**Municipal Services Center, Council Chamber
3600 Tremont Road**

BZAP Meeting Date: November 5, 2025

Subject: 2721 Kent Road (VAR-47-25) - To allow a front porch which results in ~~34.6~~ 31 percent building coverage and ~~57.6~~ 54 percent development coverage, in lieu of the 29 percent and 50 percent maximum limits. *[Postponed from October 15, 2025 BZAP hearing.]*

2 SITE PLAN - NEW WORK
 SCALE: 1" = 20'-0"

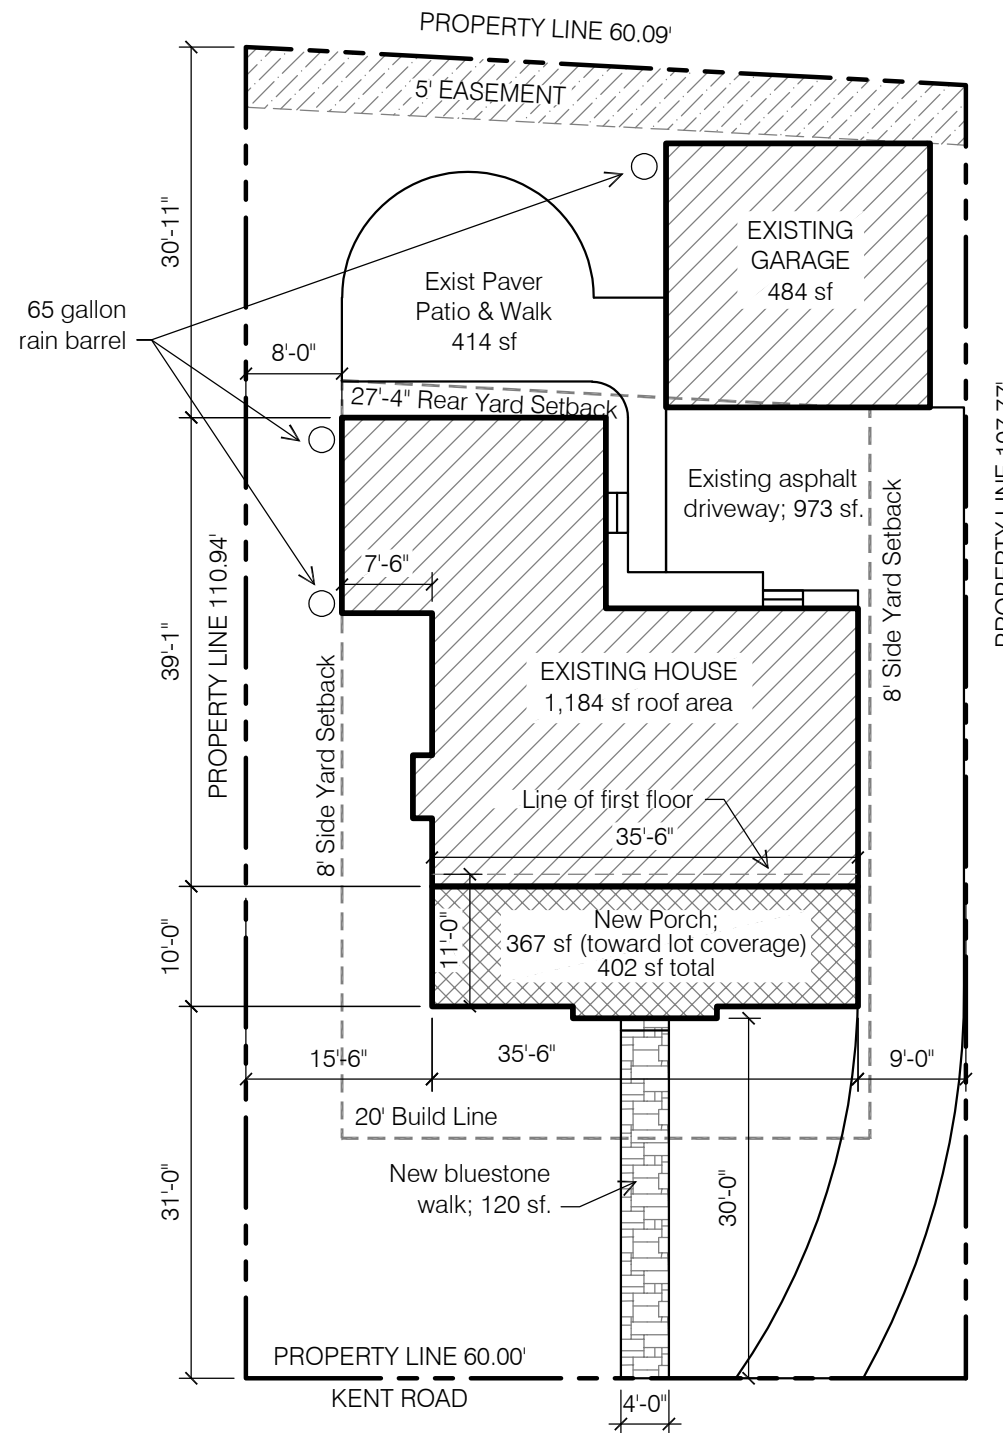
The proposal includes the construction of a covered porch that results in building and development coverage beyond limits of the code. The proposed 12'-2" tall shed roof consists of a gable above the front door and wraps around the east (side) elevation; it would be below two existing second floor windows. It is 11 feet deep on the front elevation and up to 7'-6" on the side elevation, which includes an existing chimney. [The proposed depth of the porch is driven by a future furniture plan, while the wrap-around design helps solve interior floor plan challenges.] The new porch would exceed maximum building cover limits by 372 square feet and maximum development cover limits by 501 square feet. Three new rain barrels would be added to help offset any additional stormwater resulting from the excess coverage.

Staff has reviewed the application and plans and visited the site. The proposed covered porch improves the elevation of the home by reducing its scale and massing, and creating a more welcoming appearance and entry. However, the resulting variances are substantial and well-above what is traditionally the Board's comfort level for such requests. The proposed porch also brings the roofing closer to Kent Road than every other home on the street. Staff understands and appreciates the challenges associated with shallow lots like this one, but the proposal is too great for Staff to support at this time due to the resulting overdevelopment and how much it "sticks out". Staff would recommend that the applicant look to reduce the depth of the porch along both elevations, so that both building and development coverage are reduced, as well as the amount in the front yard. The November Work Session may be an option for the applicant to consider if an alternate is not present in advance of (or at) the hearing.

At the October 15, 2025, BZAP meeting, this application was postponed so that the applicant could explore options to reduce the severity of the two requested variances. The Board expressed concern about the excess coverage and wanted the applicant to reconsider the depth of the front porch. A revised plan was submitted that eliminated the side porch (-239 square feet), but retained the front porch as originally proposed. The applicant reviewed the proposed depth of the front porch and felt that any further reductions would hinder its comfort and design.

- To increase the maximum building coverage limit from 29 percent to ~~34.6~~ 31 percent (+~~372~~ 133 SF); and
- To increase the development coverage limit from 50 percent to ~~57.6~~ 54 percent (+~~504~~ 262 SF).

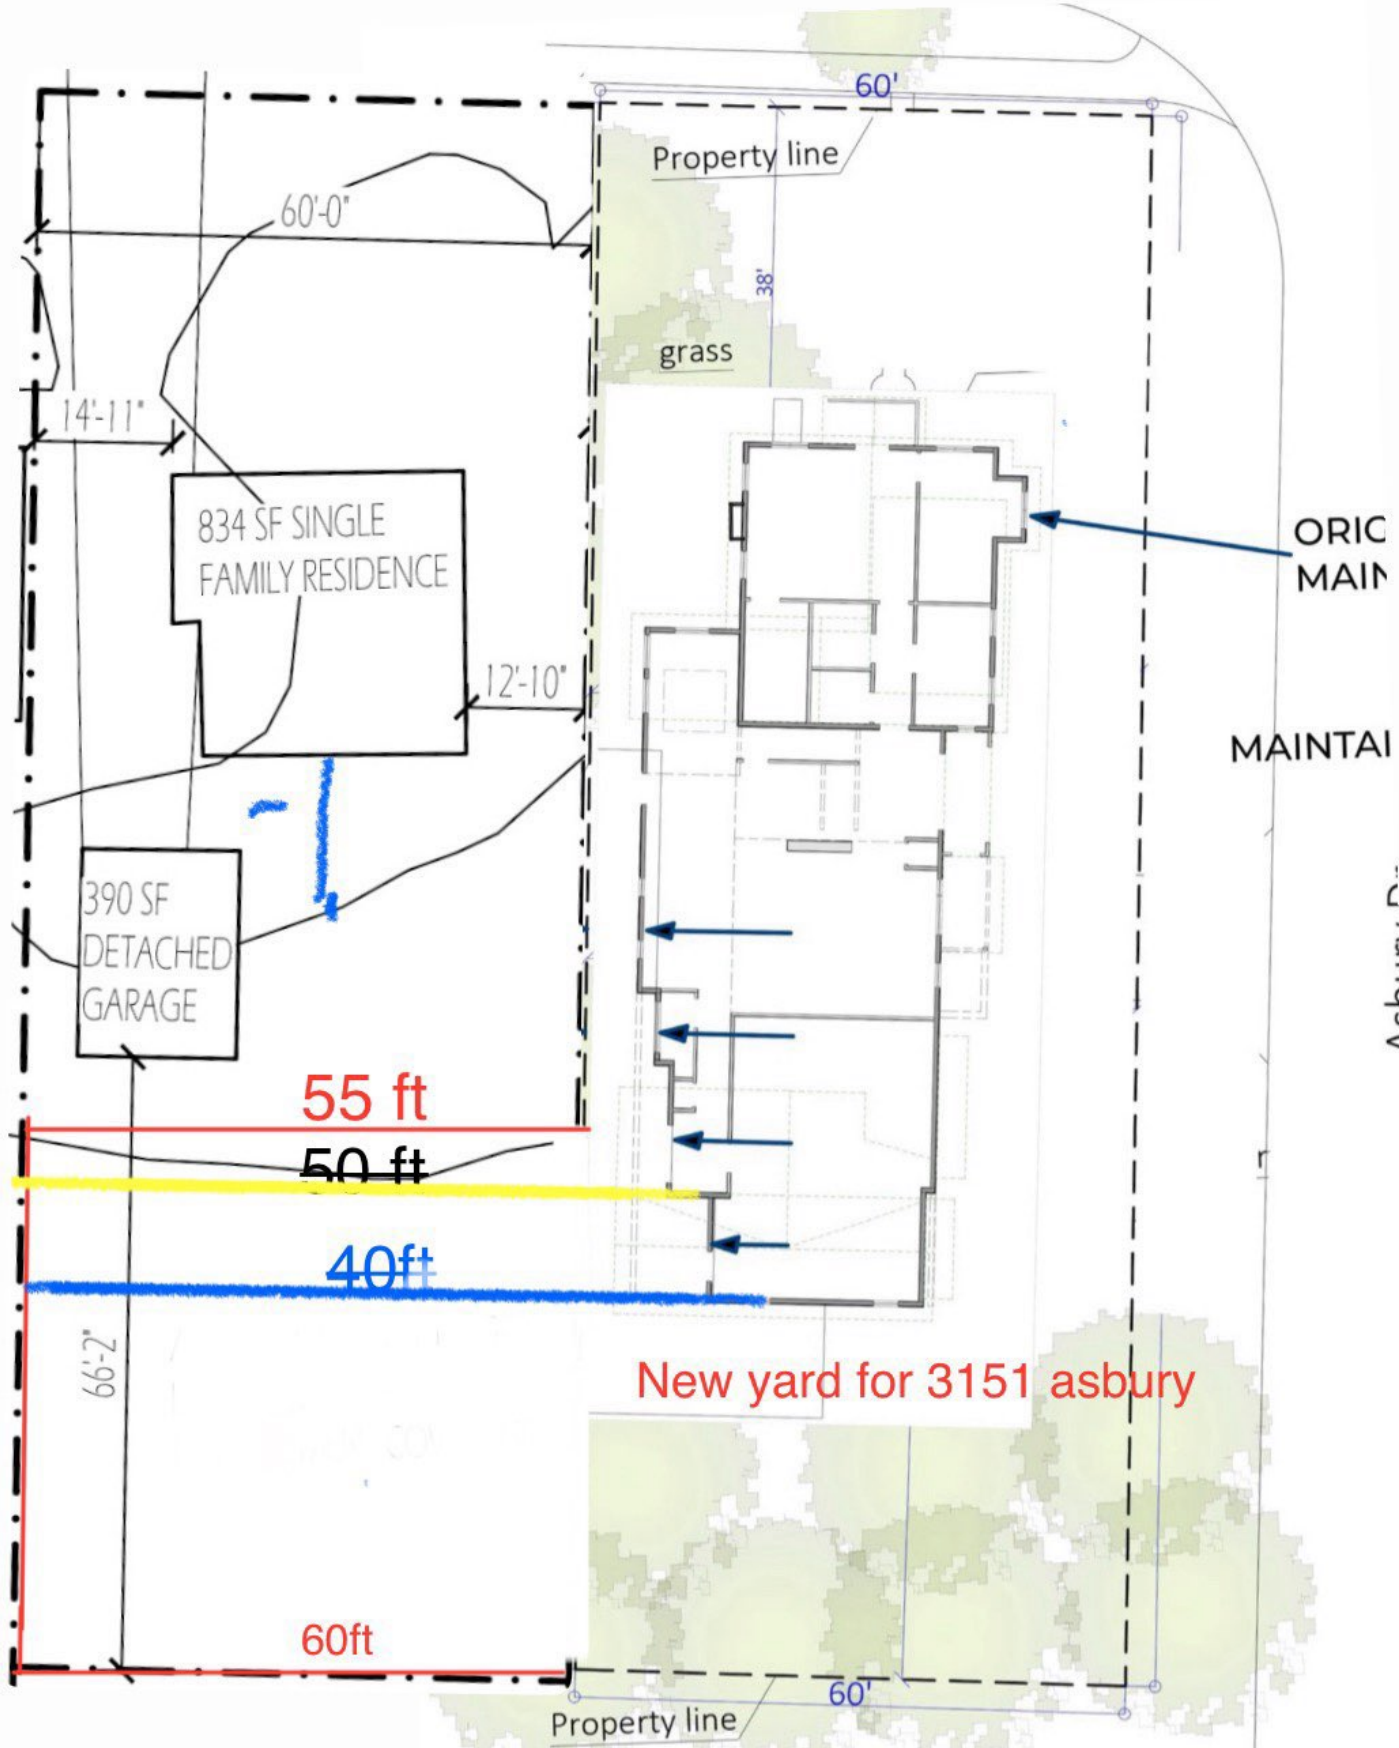
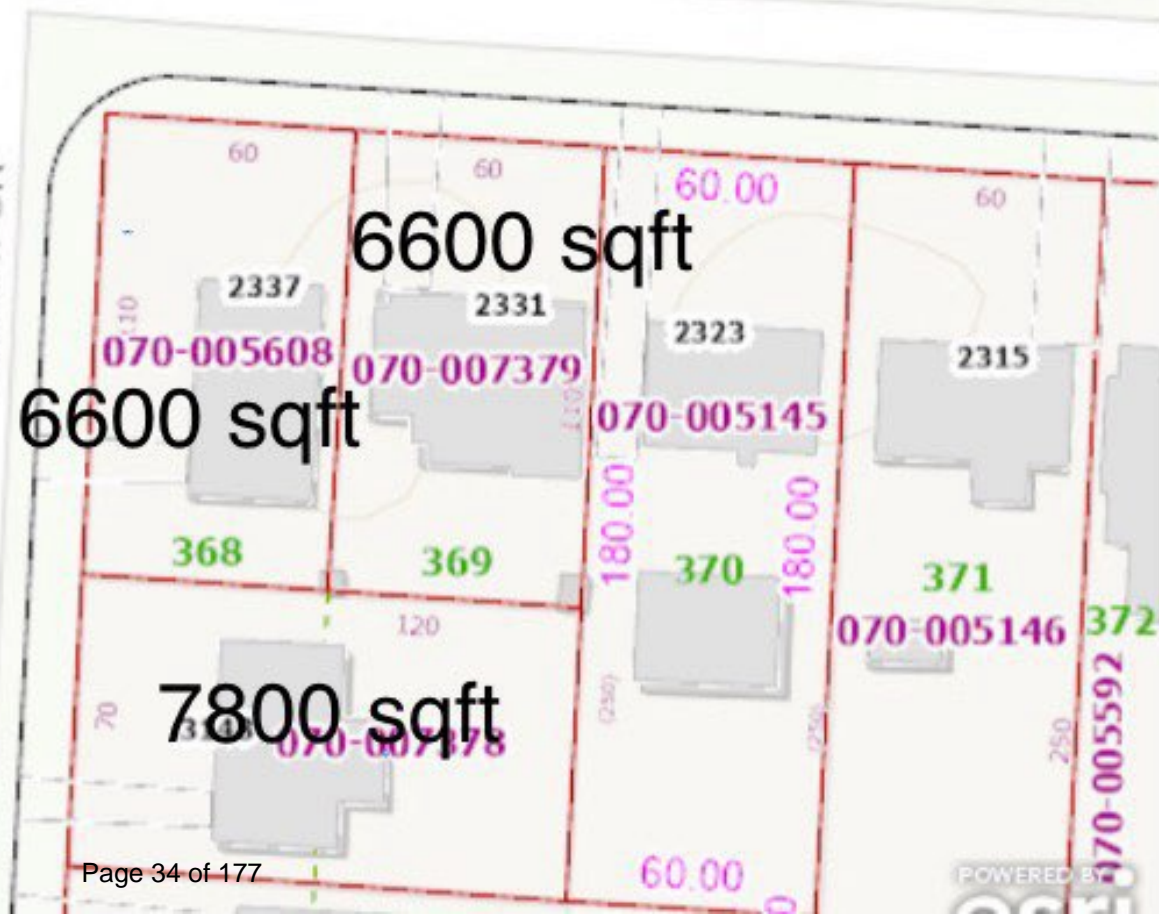
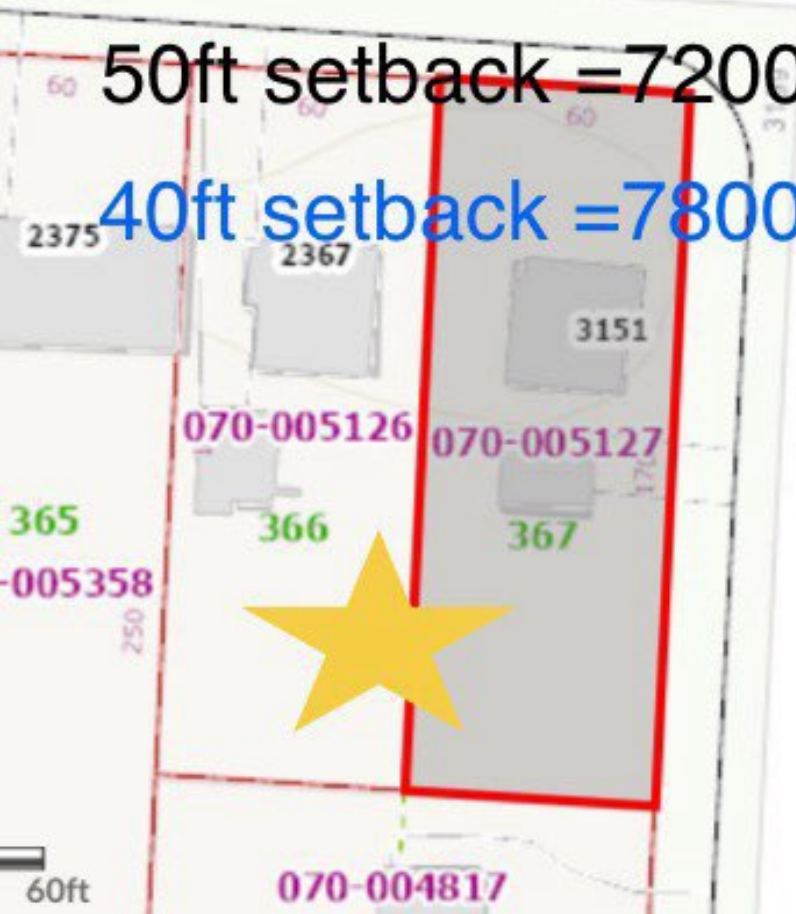
It makes the backyard a lot more narrow and pushes everything farther from the back doors about 10 to 35 feet from both back doors.

The grading drops almost 2 feet between the 55-foot and 40-foot mark, and the neighbor to the left already slopes back toward us, so we would likely have standing water issues if we cut it short.

And if we ever put in a pool, it would sit much more exposed to Asbury Street instead of being tucked behind the house where it belongs.

Existing and Proposed Lot Lines

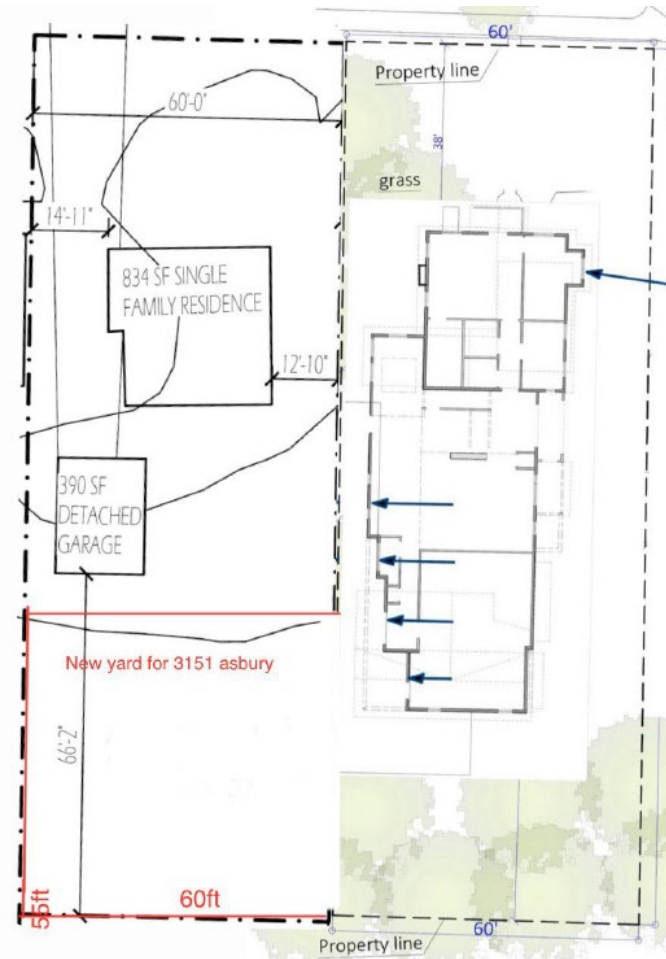
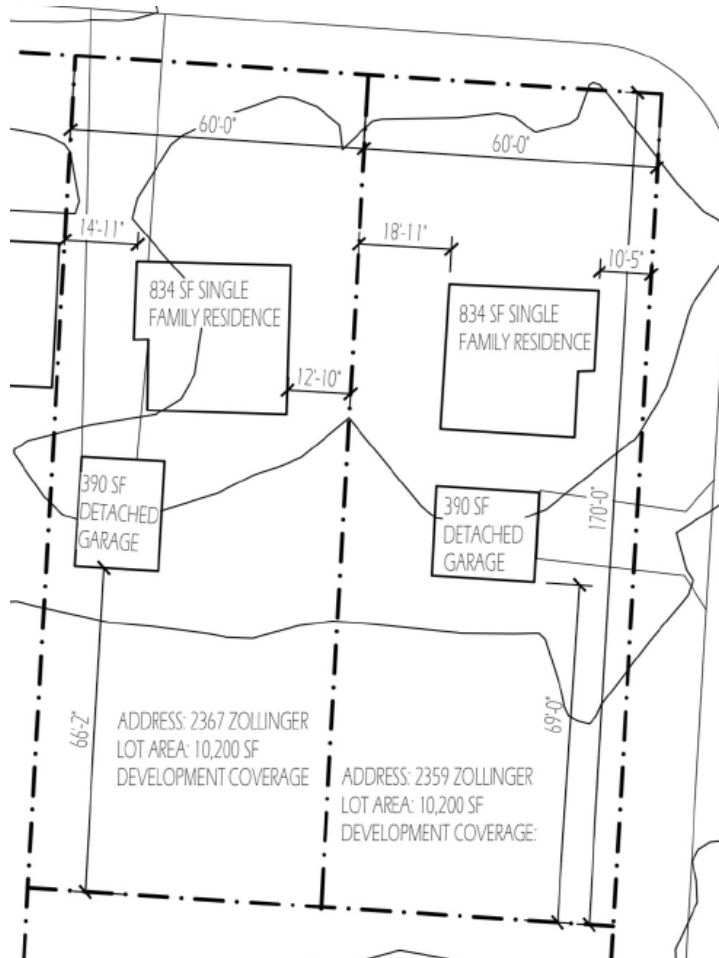
Change in Depth	Change in Area (code minimum is 9,000 SF)
2367 Zollinger Road	170' to 110'	10,200 SF to 6,900 SF (variance required)
3151 Asbury Drive	170' (no change)	10,200 SF to 13,500 SF

Staff has reviewed the application and plans, discussed it with the applicant, and visited the site. The applicant believes that expanding the corner parcel would make his project more valuable and marketable. They also believe that the change in lot lines would be imperceptible to laypersons; the only visual change would be a potential new swimming pool and fencing located behind the building setback line, and not visible from the street. The applicant pointed to properties to the east that would be similar in size to 2367 Zollinger Road, and to the south, for a similar configuration as 3151 Asbury Drive. Staff recognizes these circumstances, but is concerned about the significant reduction in property size (by one-third) of the interior parcel. Should the Board entertain a motion, Staff would recommend the following findings be considered: #4 (Essential character of the area), #8 (Spirit and intent of the zoning), #9 (Special privileges).
